CASE NO. FP-2022-0013

ORDER OF CONDITIONAL
APPROVAL OF FINAL PLAT

SUBJECT: FP-2022-0013
Aviator Springs No. 1

Final plat consisting of 95 buildable lots (93 single-family residential & 2 commercial) and 13 common lots on 25.35 acres of land in the R-8 and L-O zoning districts for the first phase of Aviator Springs Subdivision.

B. Final Plat (dated: 4/7/22)

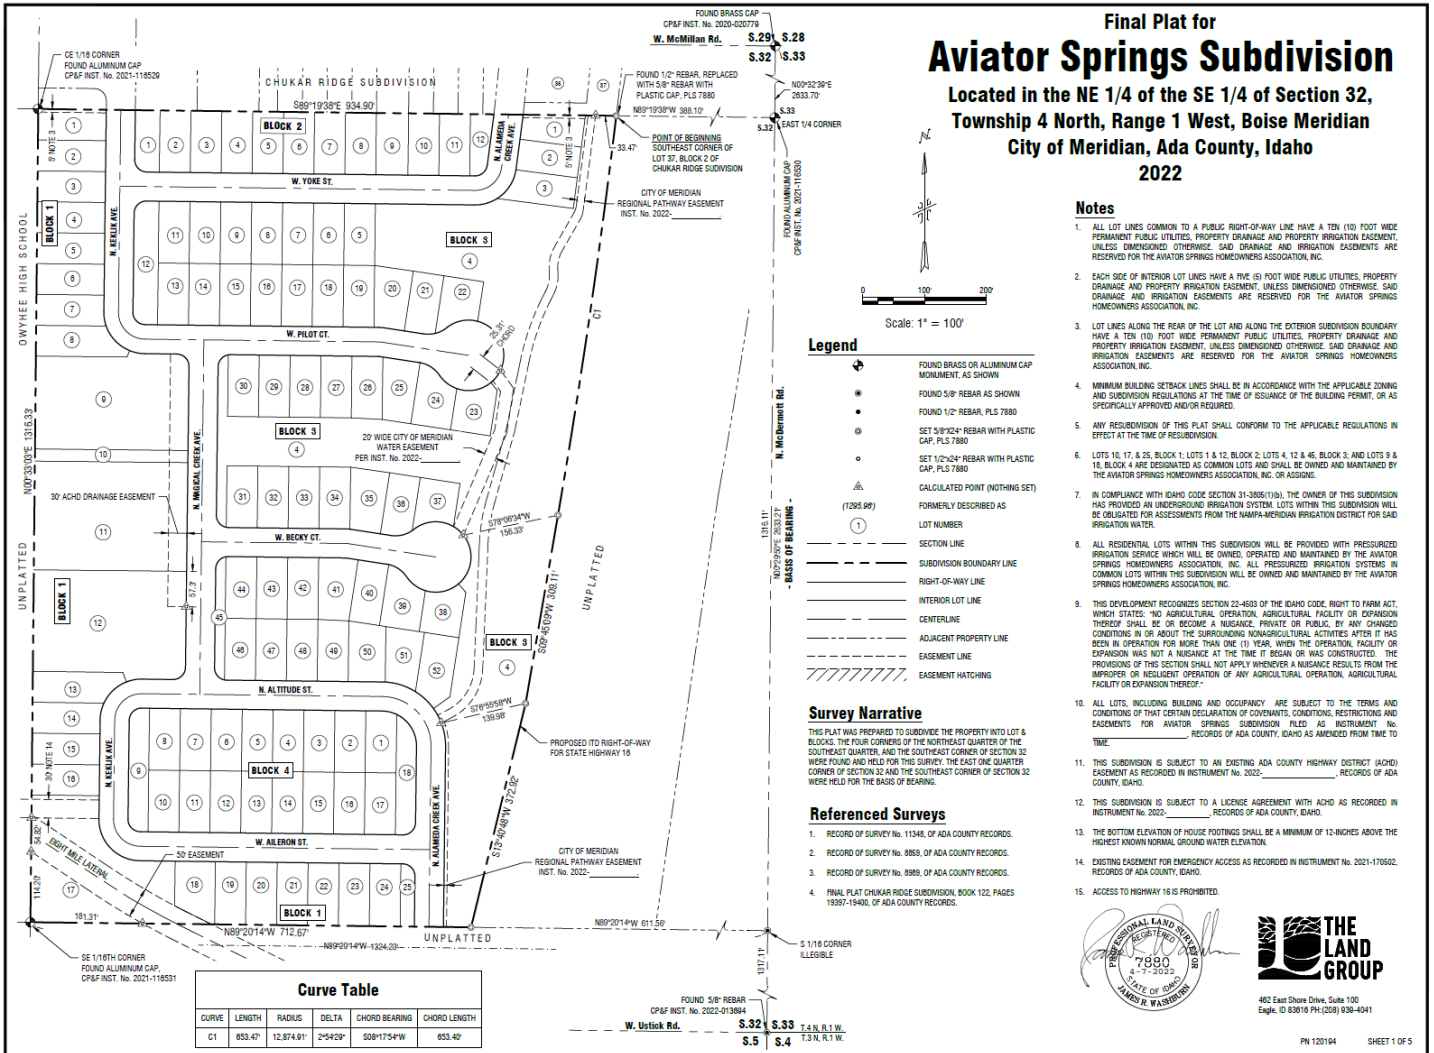
3. Prior to submittal for the City Engineer's signature, have the Certificate of Owners and the accompanying acknowledgement signed and notarized.
4. The final plat prepared by The Land Group, stamped by James R. Washburn, dated: 4/7/2022, included in Section V.B shall be revised as follows:

- a. Note #6: Include Lot 9, Block 2 as a common lot.
 - b. Note #10: Include the recorded instrument number for the CC&R's.
 - c. Note #11: Include the recorded instrument number for the existing ACHD easement.

- d. Note #12: Include the recorded instrument number of the ACHD license agreement.
 - e. Include the recorded instrument number of the City of Meridian regional pathway easement graphically depicted on the plat.

- f. Include the recorded instrument number of the City of Meridian water easement graphically depicted on the plat.
 - g. Include "Phase 1" in the subdivision name.

- h. Graphically depict a minimum 35-foot wide street buffer along future SH-16 in a common lot or on a permanent dedicated easement in accord with UDC 11-3B-7C.2.

A copy of the revised plat shall be submitted with the final plat for City Engineer signature.

C. Landscape Plan (dated: 04/7/2022)

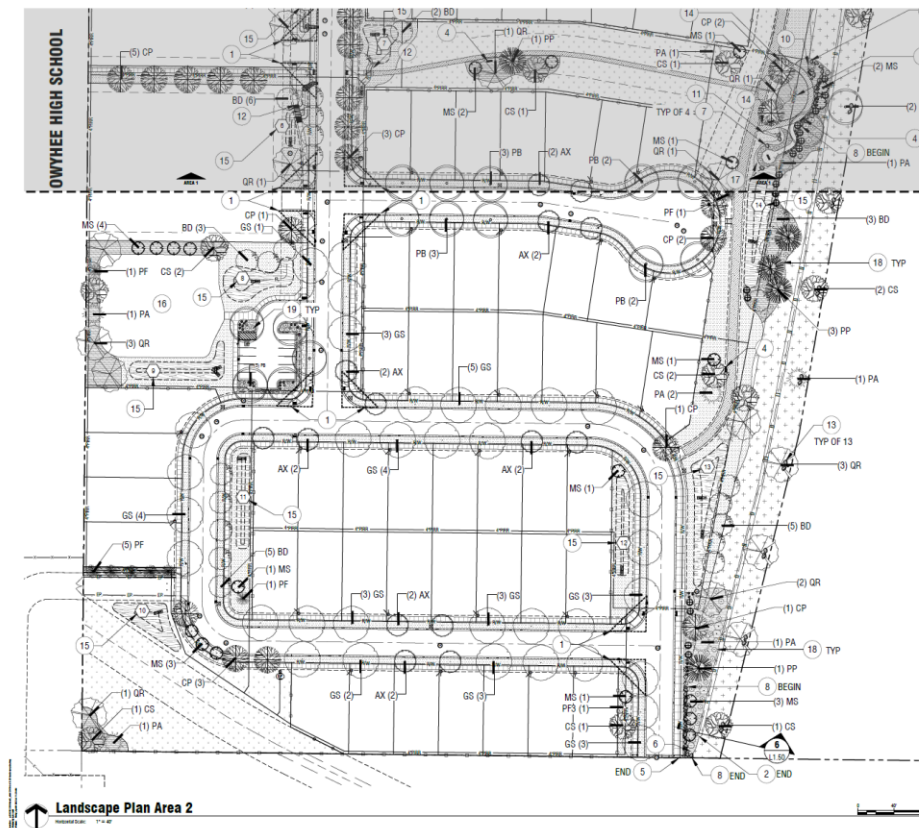
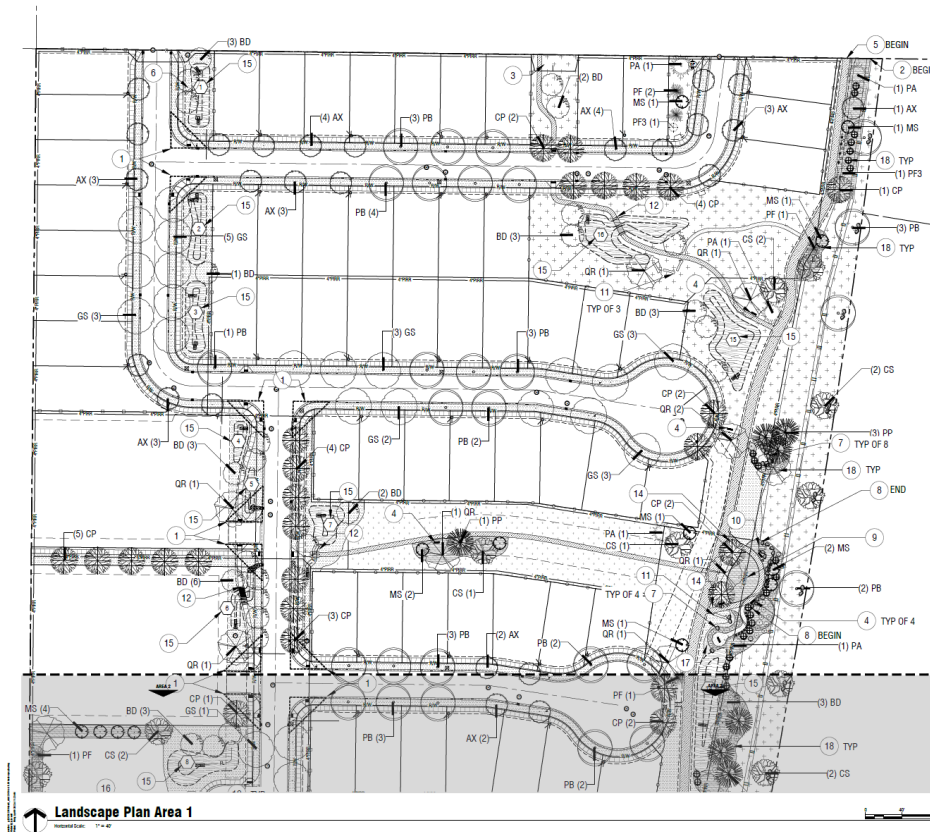
5. The landscape plan prepared by The Land Group, Inc., dated 4/7/2022, included in Section V.C, shall be revised as follows:
 - a. In Project Calculations table, include the required number of residential subdivision trees as set forth in UDC 11-3B-7C (1 per 35', may deduct 26' for each driveway); include the required number of trees along micro-paths as set forth in UDC 11-3B-12C.2 (one tree per 100').

- b. Include the tree classification (i.e. I, II or III) in the Plant Schedule. All parkway trees should be Class II in accord with UDC 11-3A-17E.
 - c. Include a detail of the proposed wall along the east boundary along future SH-16 that demonstrates compliance with the standards in UDC [11-3H-4D.3](#).

- d. All stormwater swales incorporated into required landscape areas shall comply with the standards listed in UDC [11-3B-11C](#).
 - e. The pathway on Lot 10, Block 1 shall be redesigned/relocated so that landscape strips are provided on each side of the pathway in accord with the standards listed in UDC [11-3B-12C.1](#).

- f. Depict landscaping along all pathways in accord with the standards listed in UDC [11-3B-12C.2](#); include a mix of trees, shrubs, lawn and/or other vegetative groundcover.

A copy of the revised landscape plan shall be submitted with the final plat for City Engineer signature.
